**REQUEST FOR TENDER No. 21-025**

**Sludge Storage Cell 3 Replacement**

**Addendum 2**

<b>REGIONAL DISTRICT OF NANAIMO</b>	<i>Request for Tenders No. 21-025</i> <b>Sludge Storage Cell 3 Replacement</b> <u><b>Addenda-2</b></u>	Date: March 31, 2021 Revision: 0
---	--	-------------------------------------

## **APPENDIX 1 – DRAFT FRP TANK SHOP DRAWINGS (3 SHEETS)**

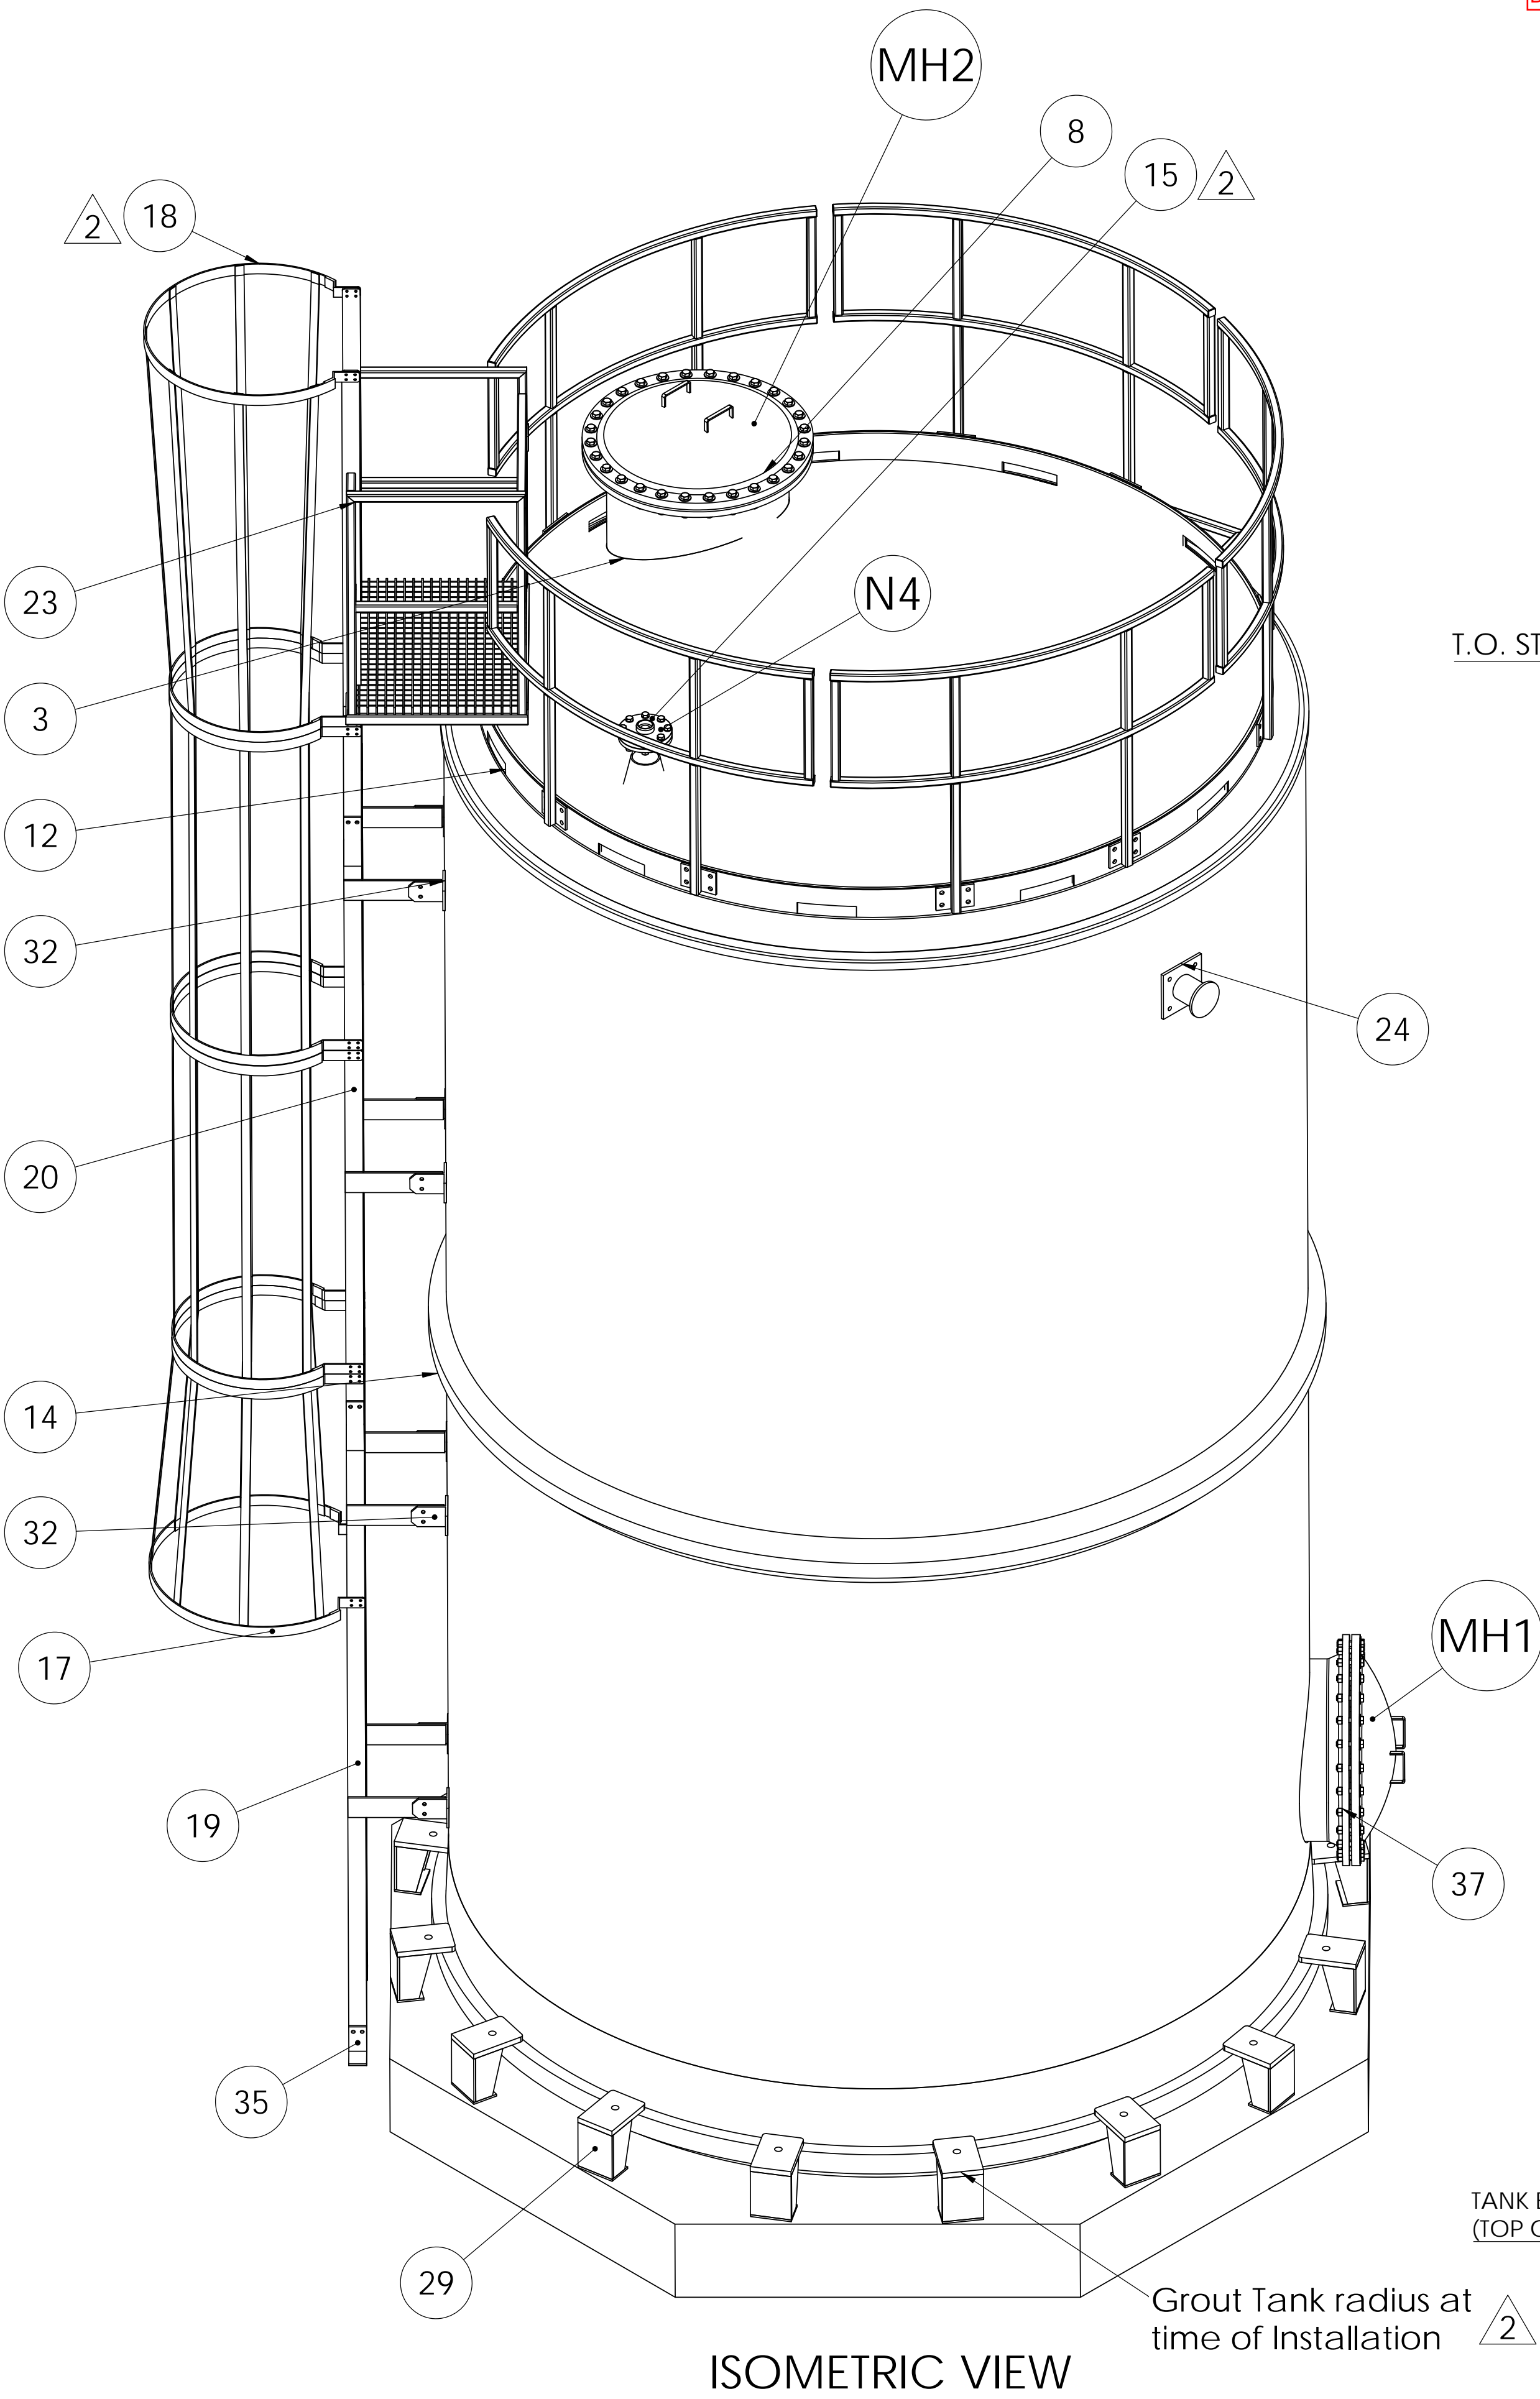
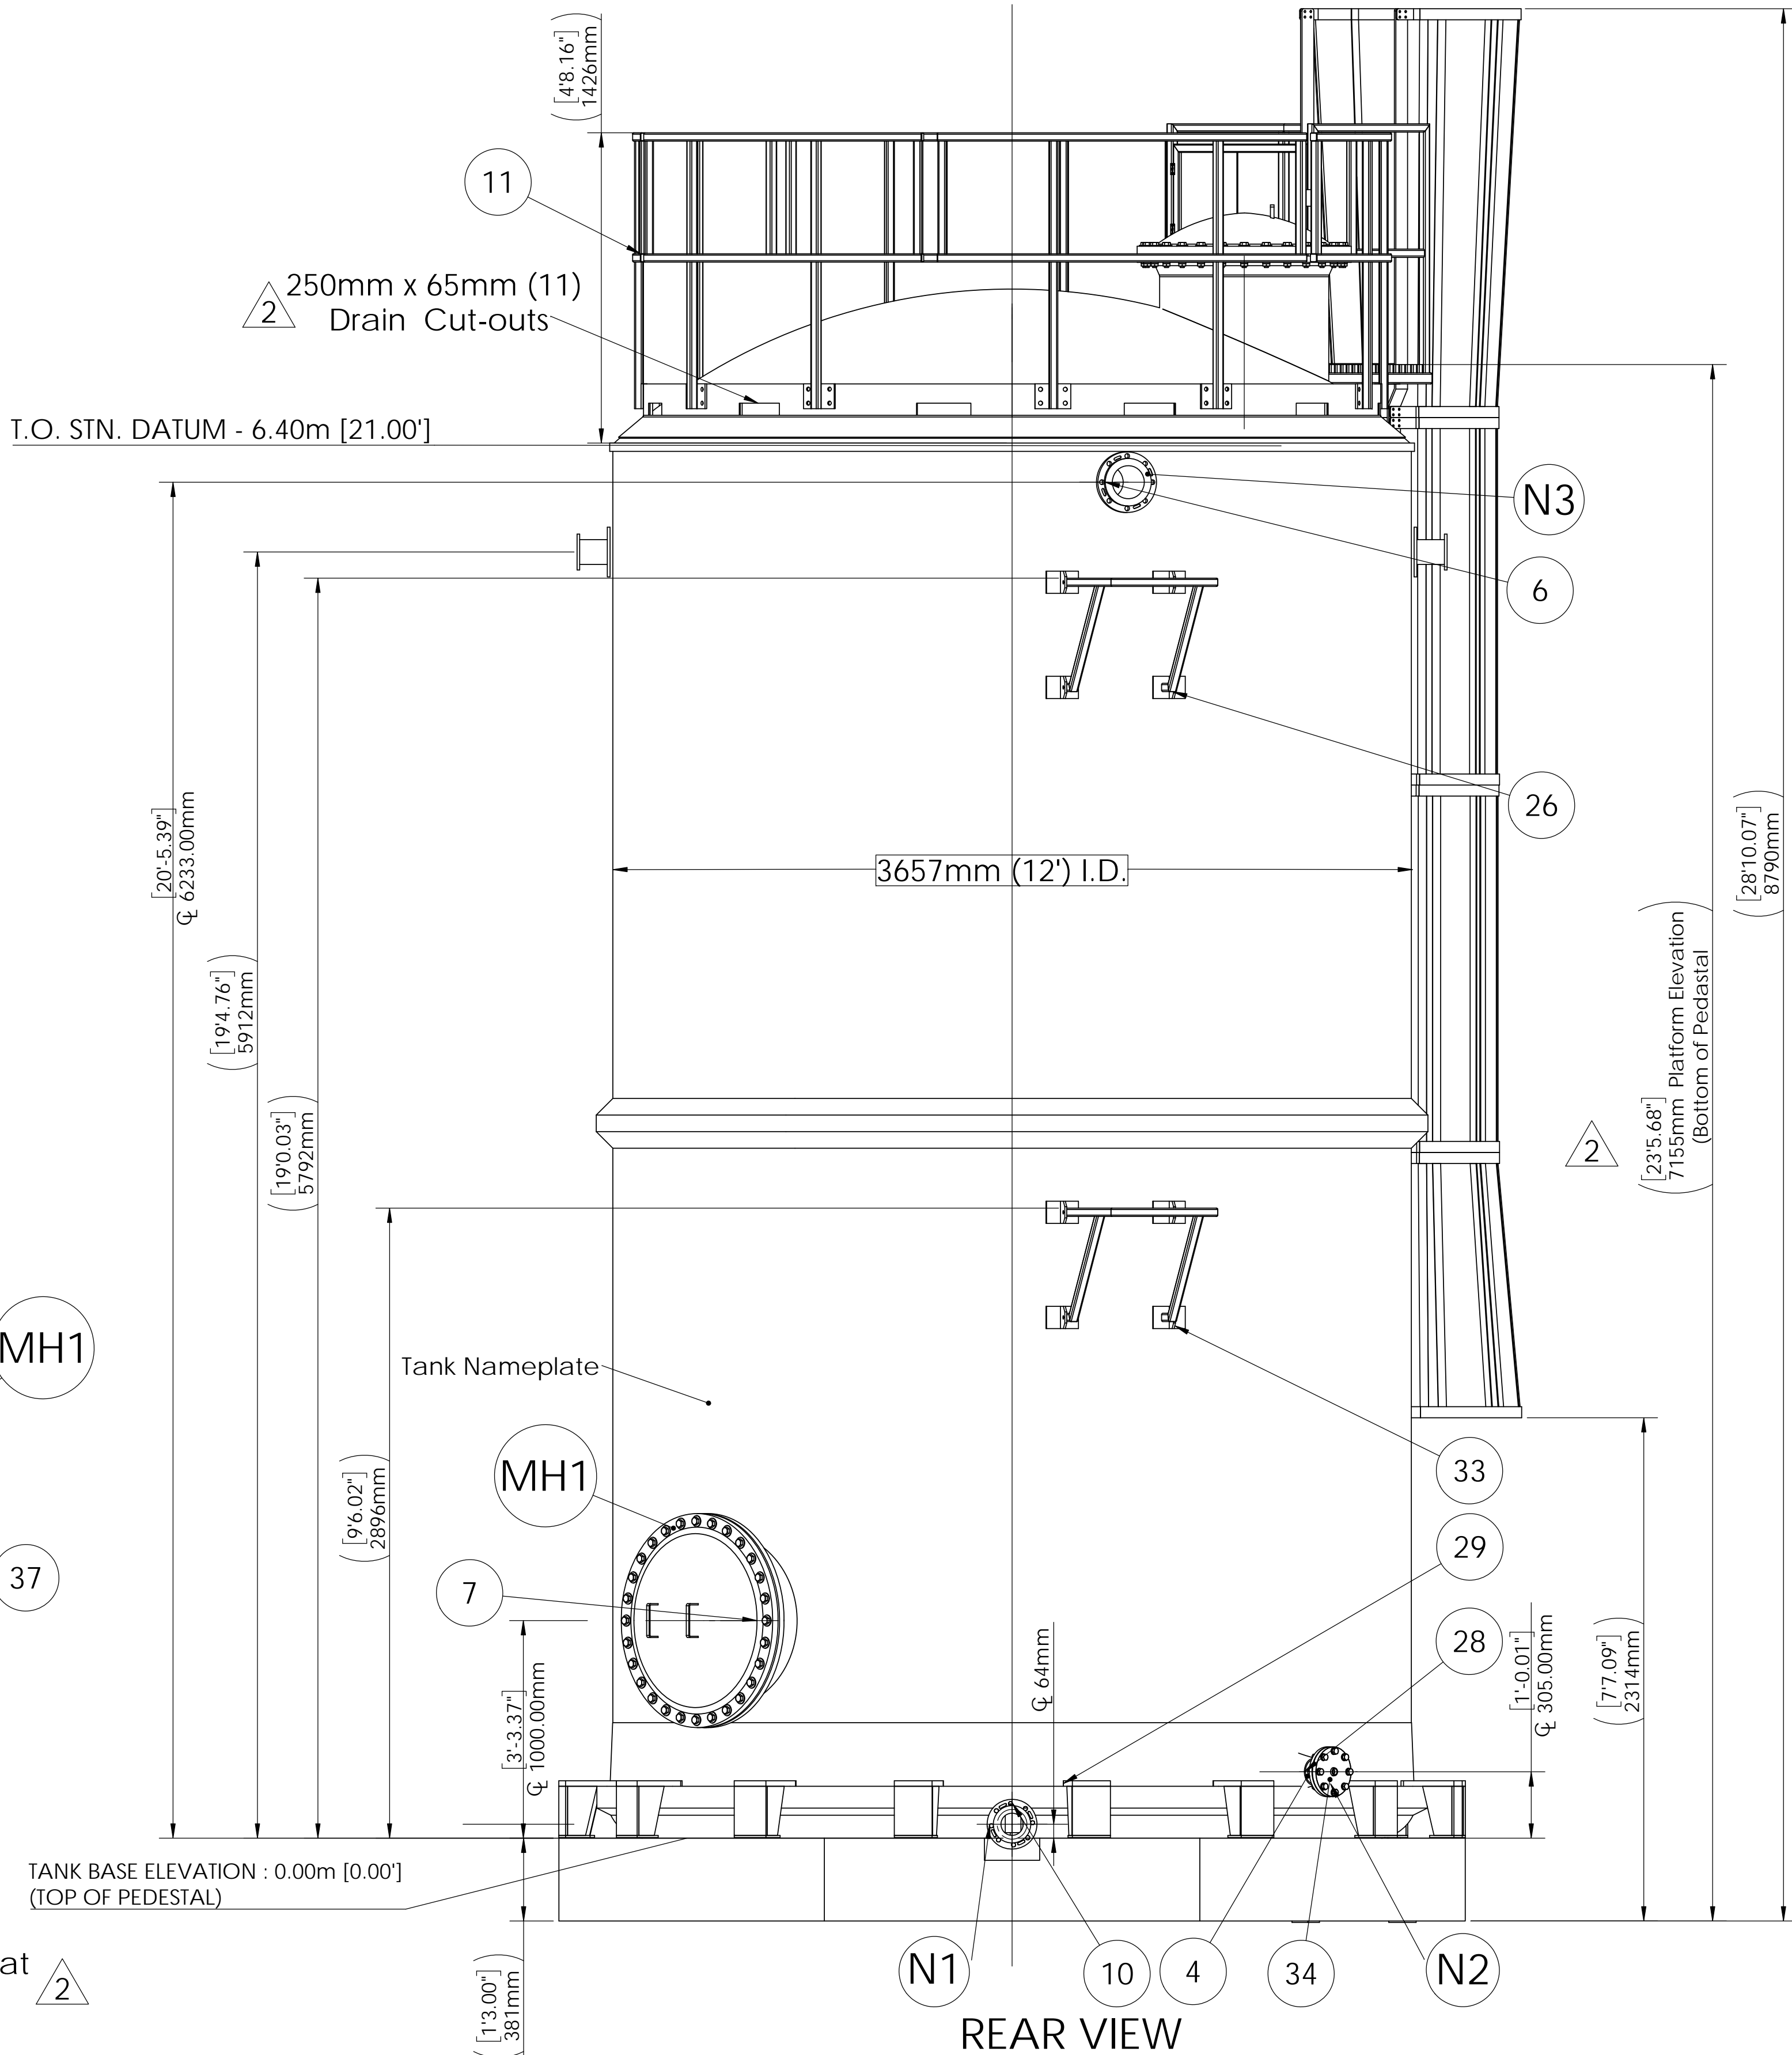
1. **Note** – The tender closing date is revised from Friday April 16, 2021 to **Friday April 23, 2021**.
2. **Note** – Please refer to the attached draft sludge storage cell 3 shop drawings from the FRP tank fabricator. These are provided for information only. Final approved shop drawings will be provided to the successful bidder upon award.

18. **Question:** Will the tank fabricator be supplying a bolting template/layout or will the tank be shipped to site and we will have to provide or own?

19. **Question:** Where are the new tank lifting lugs located?

**Answer:** *The tank fabricator will not be supplying an anchor bolt template. The clamp bracket anchoring design is conceived to allow for minor deviations in anchor bolt location. Please refer to the tank fabricator's draft shop drawings for additional information. The Contractor remains responsible for meeting the anchor bolt tolerances necessary for installation of the tank as per the Drawings.*

**Answer:** *Please refer to the tank fabricator's draft shop drawings for lifting trunnion locations. The lift must be completed using a spreader bar on the main crane line and a tail crane connected to the tank bottom with a long webbing choker sling.*
